TA-16

Date: May 7, 1999
Refer to: EM/ER:99-120

SUBJECT: SUBMITTAL OF CLASS 1 CLOSURE PLAN MODIFICATION FOR MDA-P AND RESPONSE TO COMMENTS CONTAINED IN THE MARCH 10, 1999 LETTER FROM HRMB

MDA-P REPLACEMENT PAGES

Figure 6-2:
ESTIMATED PROJECT SCHEDULE
Date: May 7, 1999

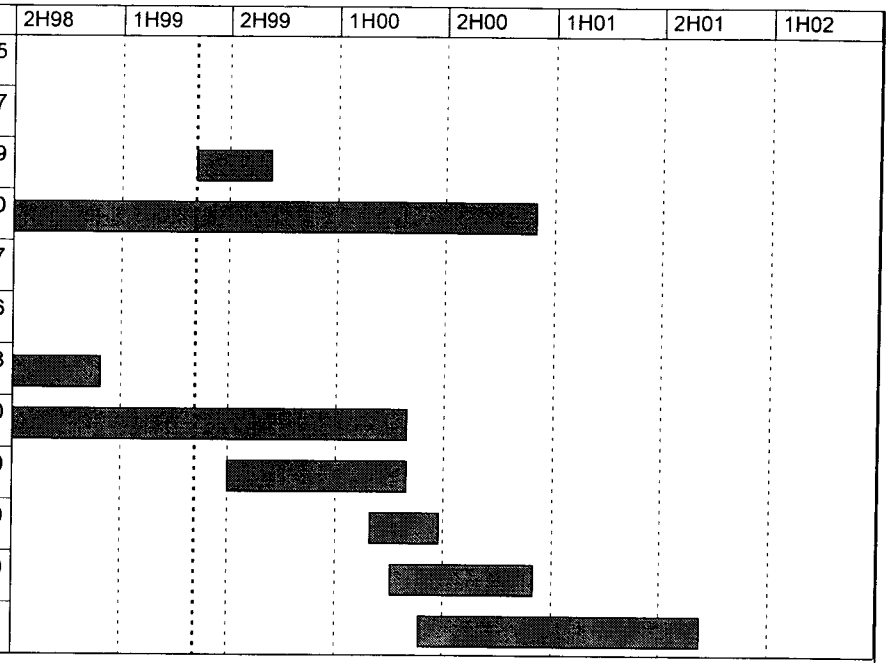
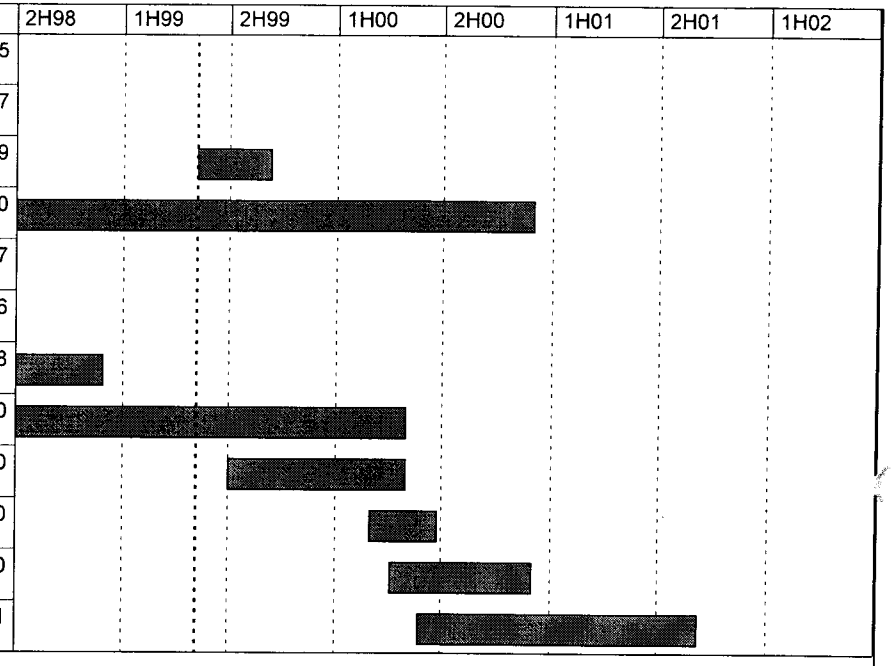
As indicated in Figure 6-2, removal of wastes and completion of closure activities will need to be extended until September 2001. If completion of final closure activities will take longer that September 2001 the Laboratory will submit a closure plan amendment in accordance with 265.112(c).
